BAYSIDE COUNCIL

Planning Assessment Report

Application Number:	DA-2016/343
Date of Receipt:	1 April 2016
Property:	398 - 412 Princes Highway, ROCKDALE (Lot 1 DP 508675)
Owner:	Hws Property Developments Pty Ltd
Applicant:	HWS Property Development Pty Ltd
Proposal:	Integrated Development - Construction of a nine (9) storey mixed use development containing 60 residential units, four(4) retail units, basement carparking, roof top communal open space and demolition of existing structures
Recommendation:	Approved
No. of submissions:	One (1)
Author:	Pascal van de Walle
Date of Report:	17 October 2017

Figure 5 - Building Height exceeding maximum 28m height limit (Princes Highway frontage)

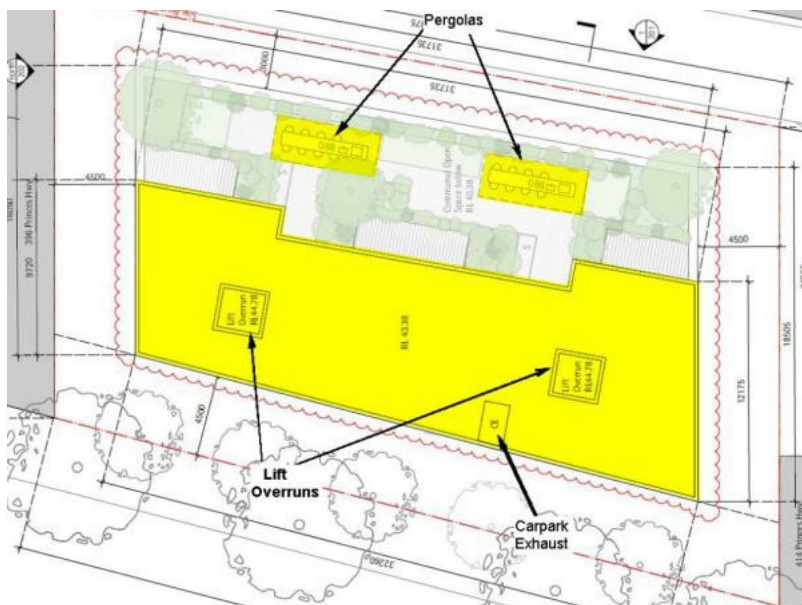
- (i) Height of building to Princes Highway = between 28.7m and 29.35m (a variation of between 0.7m - 1.35m);
- (ii) Top of pergola structures = 28.3m (a variation of 0.3m); and,
- (iii) Top of lift overrun & Carpark Exhaust Vent = 30.2m (a variation of 2.2m).

The applicant has submitted a detailed justification to the proposed variation of the height development standard in accordance with Clause 4.6 of RLEP 2011. A summary of the key rationale provided by the applicant includes:

- The bulk of the building falls within the 28m height limit, and a majority of the variation relates to the lift overrun, plant and pergola structures associated with the communal open space. The height variation for a minor part of the top residential level at the Princes Highway side of the development is setback 4.5m from the front Princes Highway boundary and 4.5m from both side boundaries. The variation to height is minor and not readily perceivable from the public domain.
